Access Compliance Report

Public Rights-of-Way

| Intersection ID: N/A | Main Street: PERIWINKLE_HILL_CT | Cross Street: N/A | Location: N |
| ADA ID: 8EF2002B421B | Ramp Type: Perpendicular Diagonal | Initial Pass/Fail: Pass | Overall Compliance: No |

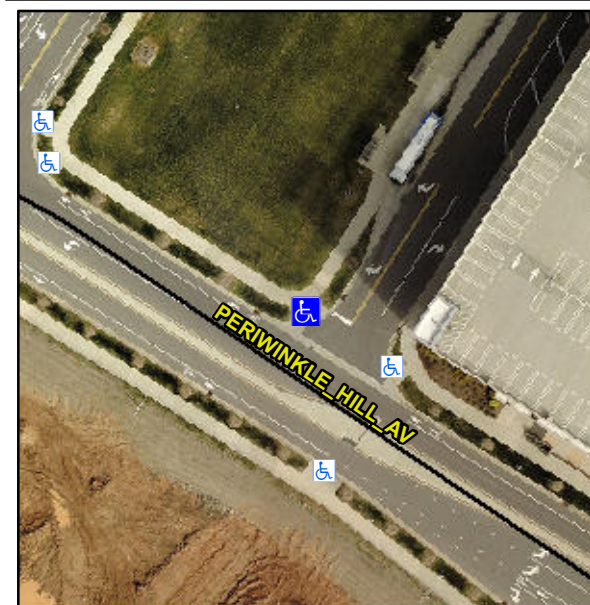
Not Found, R304.5.3

| Compliance | Description | Data | Compliance | Description | Data |
|------------|-----------------------|--------|------------|-----------------------------|-------|
| Yes | Ramp Width (in) | 48.0 | No | Ramp XSlope (%) | 4.2 |
| No | Landing X Slope (%) | 4.1 | Yes | DWS Full Width? | Yes |

Remove & Replace Curb Ramp With Two New Directional Ramps or Equivalent.
